CABINET MEMBER FOR ENVIRONMENT – 12 APRIL 2018

A4095 BURFORD ROAD WITNEY - PROPOSED SHARED USE FOOTWAY / CYCLE TRACK AND TOUCAN CROSSING

Report by Director for Infrastructure Delivery

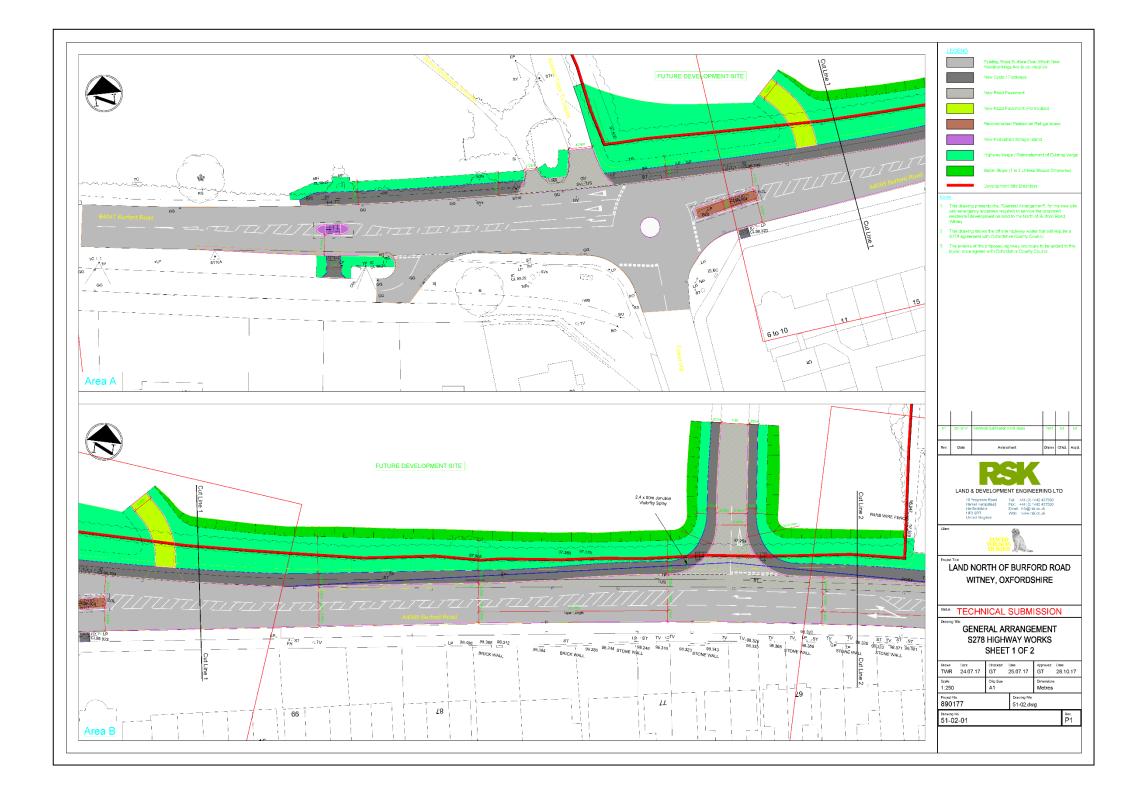
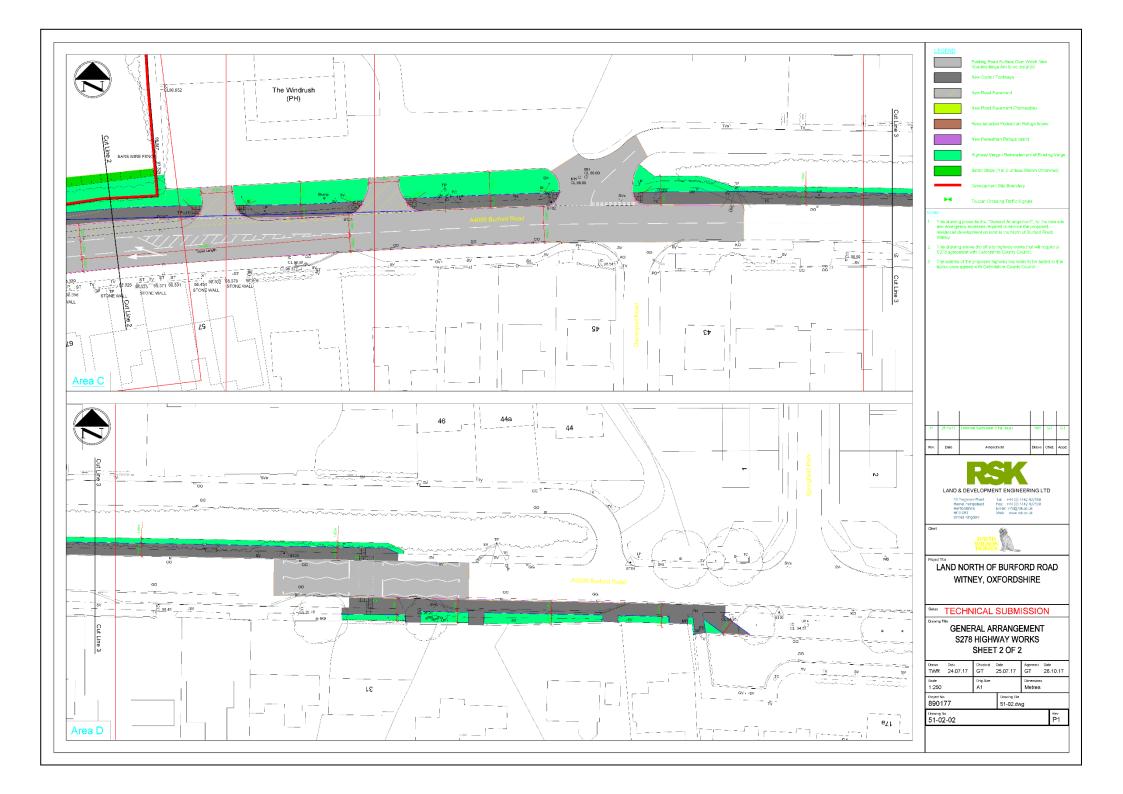
- 5. The objection of the member of the public is noted.
- 6. The Windrush Bike Project, while welcoming the principle of provision for cycling, queried the design of the cycle track where it crossed side road junctions, noting that this did not conform with the cycling design standards recently issued by the County Council. While it is accepted that this is the case, the design of this specific scheme predates the issuing of these

RESPONDENT	SUMMARISED COMMENTS
Windrush Bike Project	While welcoming additional provision for cyclists, we are concerned that the detailing of the scheme where the cycletrack crosses side road junctions is not in accordance with current OCC advice, and also query how the proposed provision fits into other existing provision on the Burford Road (which is on the south side of the road) and more generally, on wider plans for cycling provision on this corridor.
Local Resident, (Springfield Park, Witney)	Toucan Crossing - Object - no comment Shared-Use Footway - Object - no comment

standards and it is not considered feasible to amend the design at this stage, noting also that layouts of the type currently proposed typically have very good safety records.

7. The wider concerns raised about the integration of the proposed scheme with existing cycle provision and future plans for additional provision on the Burford road are also noted but it should be stressed that the current proposals do not in any way constrain opportunities for further provision for cyclists here as and when funding to deliver the latter becomes available.
